HORIZON®. HRZ-D MANUAL
ADDENDUM
June 1980

ADDENDUM to: HRZ-D MANUAL, REVISION_1

JUNE 4, 1980

We try to make our documentation as complete, clear and accurate as possible. Your suggestions and feedback on HORIZON System documentation are always welcome.

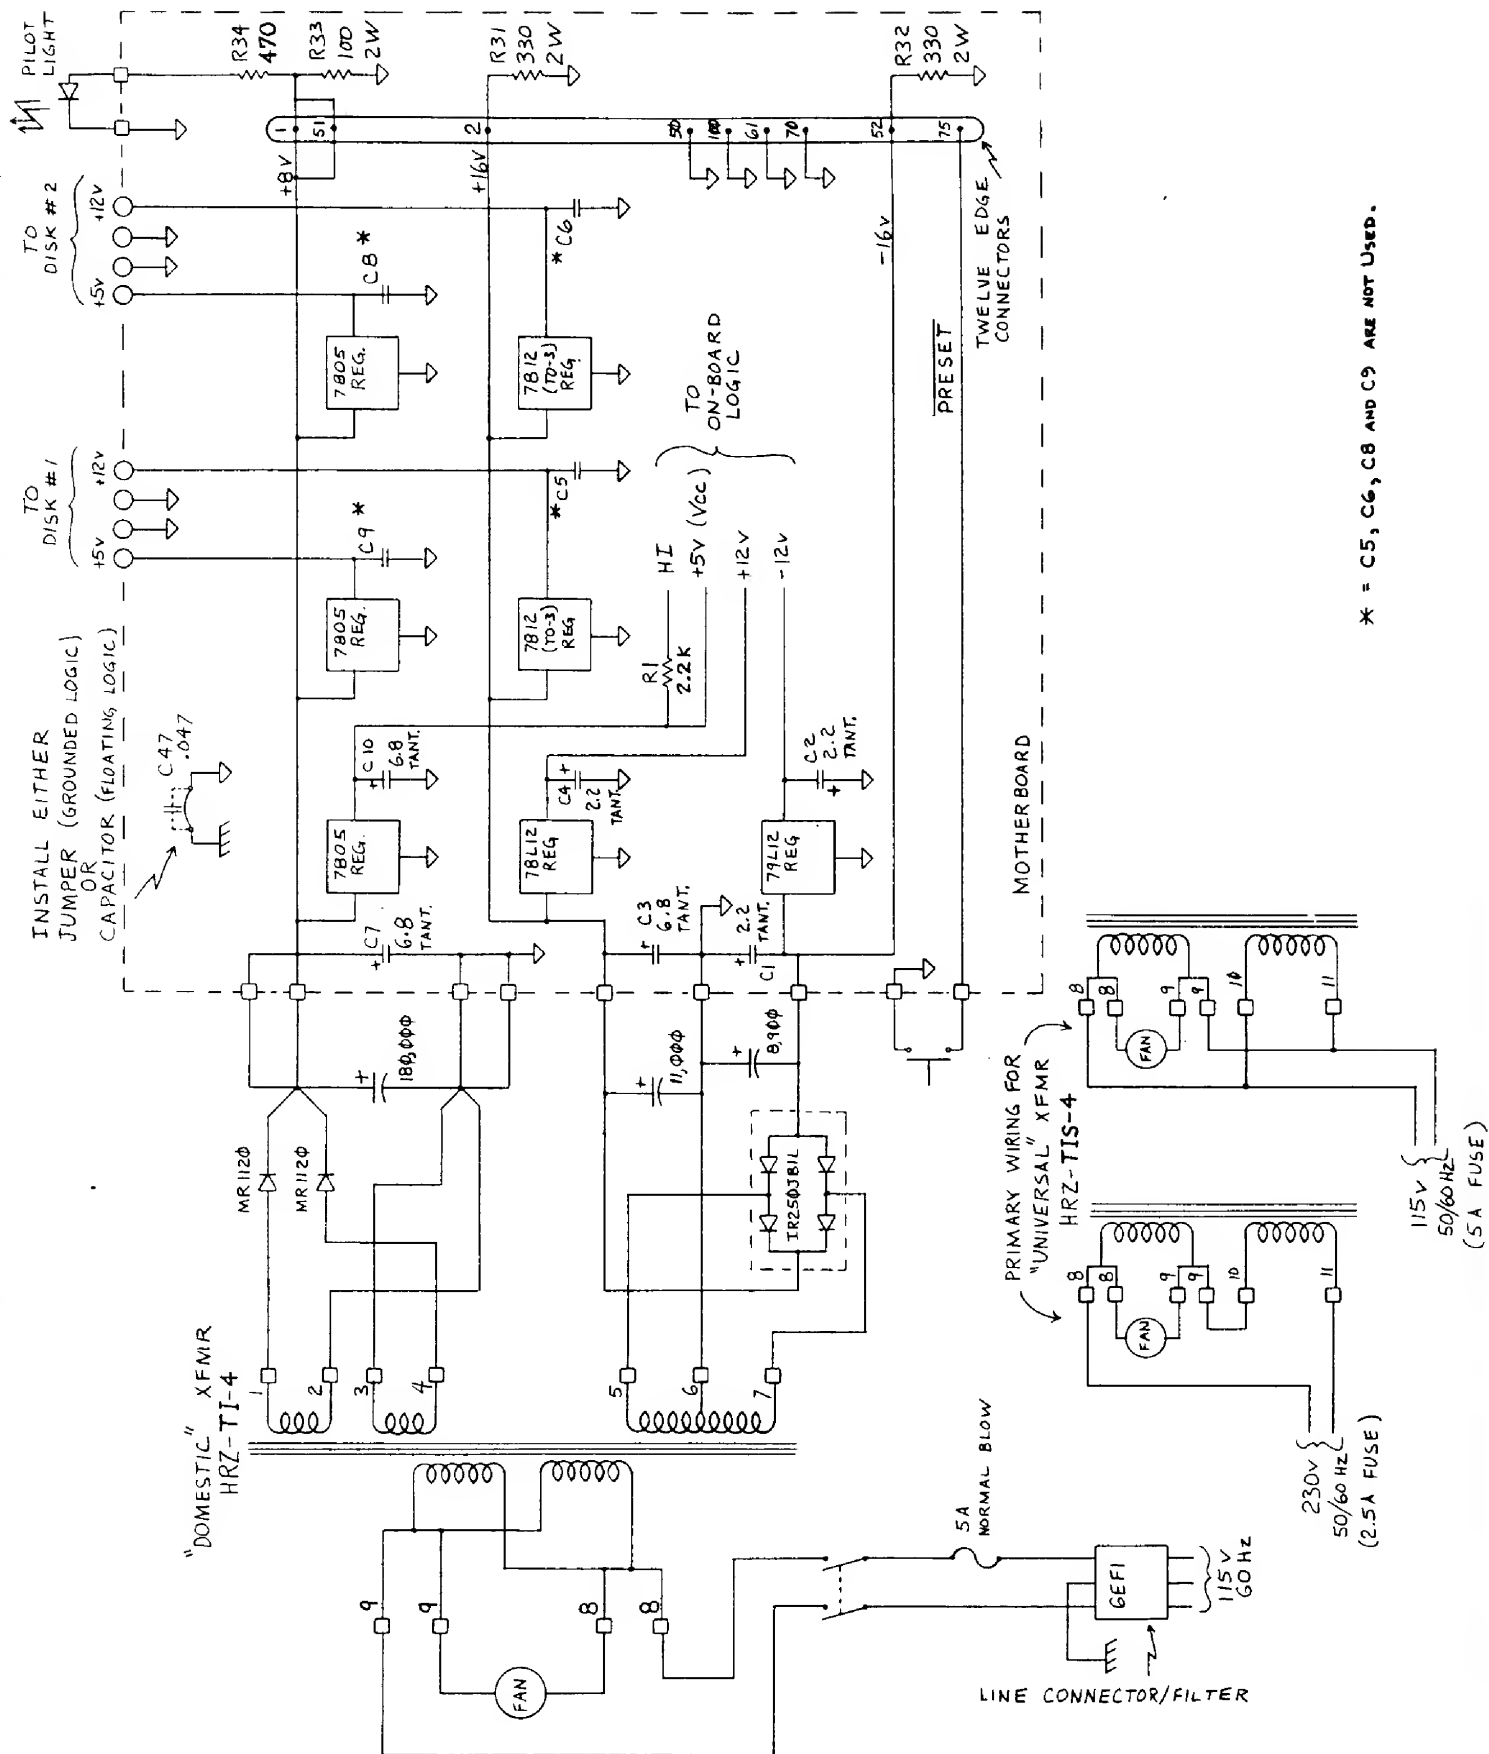
11) For all HORIZON Computer Systems containing motherboards marked "HRZ-MB-4", the following five pages of schematic drawings supersede pages 88, 89, 91, and 92 of the HORIZON Manual.
